# Agenda Item #3 Application 2024-69-CA

259 S. Broad Street

Remove aluminum siding; open existing rear porch; fenestration alterations; remove concrete steps, stoop and sidewalk on north elevation; in-kind repairs and replacements

FLOOR FLAN 1/4:1:0" SCALE

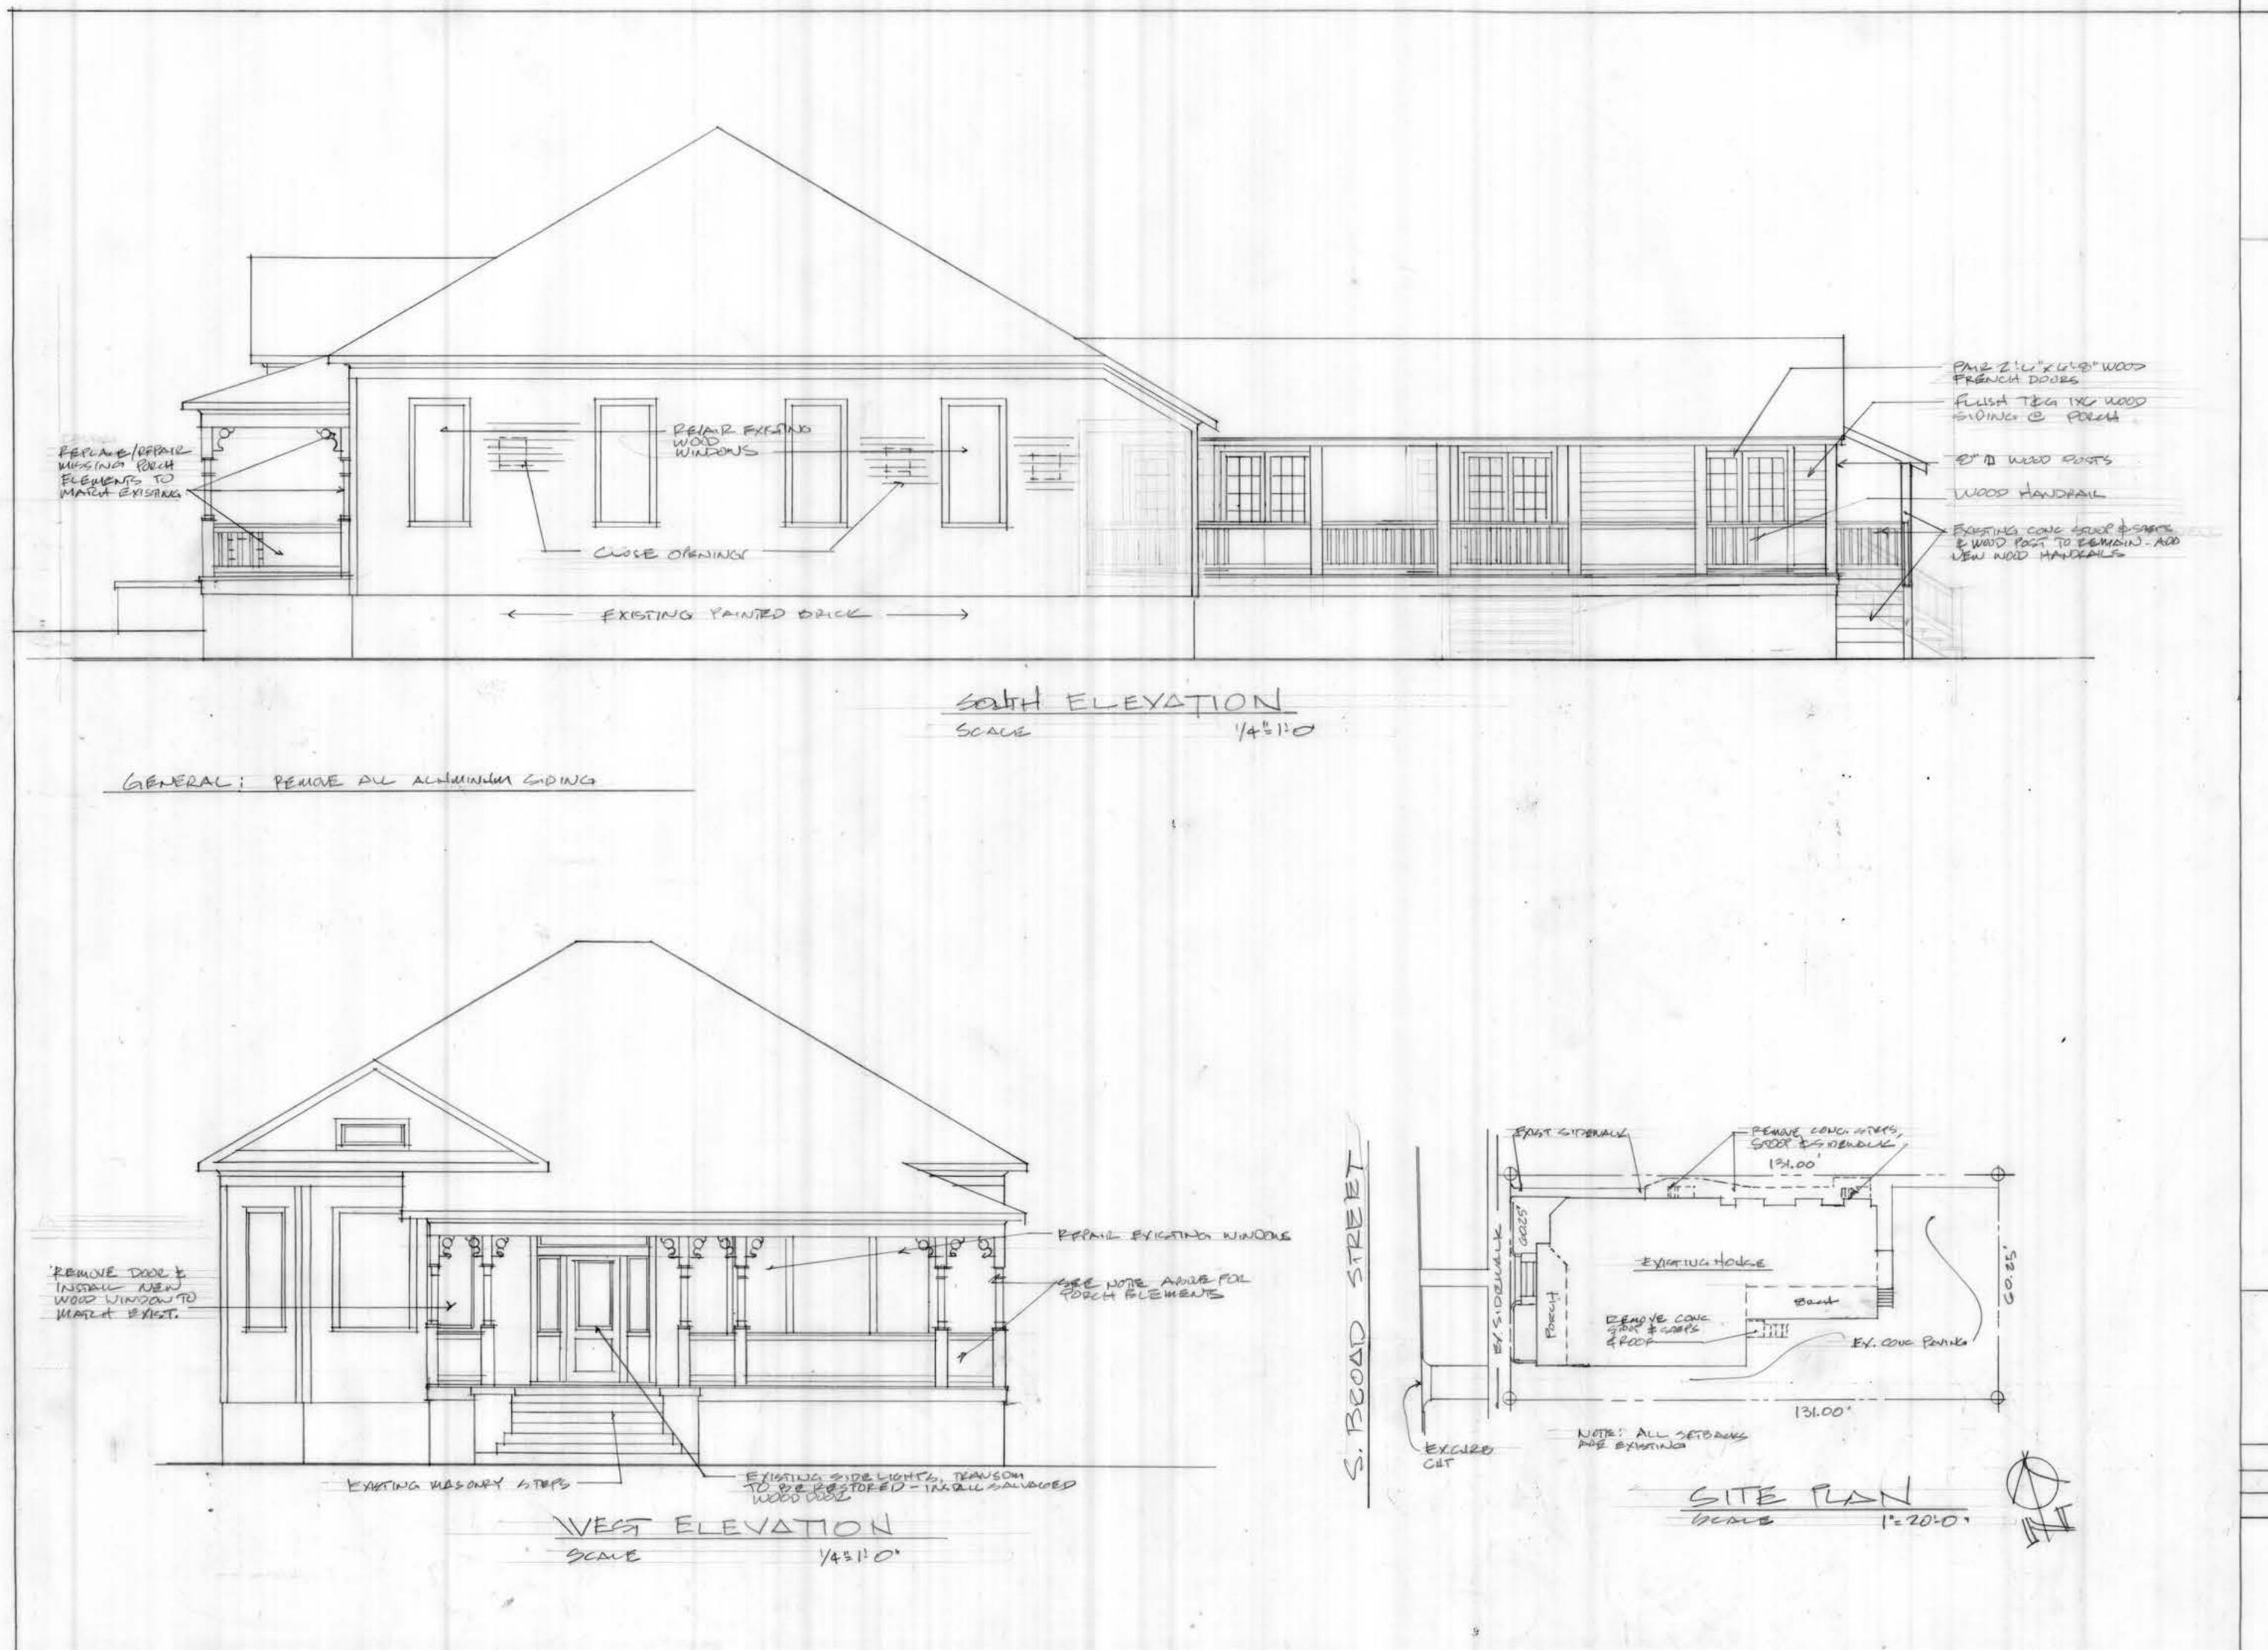
On the north and east elevations, proposed closures of existing fenestrations openings would be filled with wood siding to match existing. All proposed new windows would be aluminum-clad wood. Removed wood windows on the north elevation would be relocated as shown on submitted plans. On the south elevation of the rear projection, the proposed three pairs of French doors are consistent with the style and rhythm of fenestration of the dwelling, and comply with the Guidelines regarding material, proportion, and profile. (5.15)
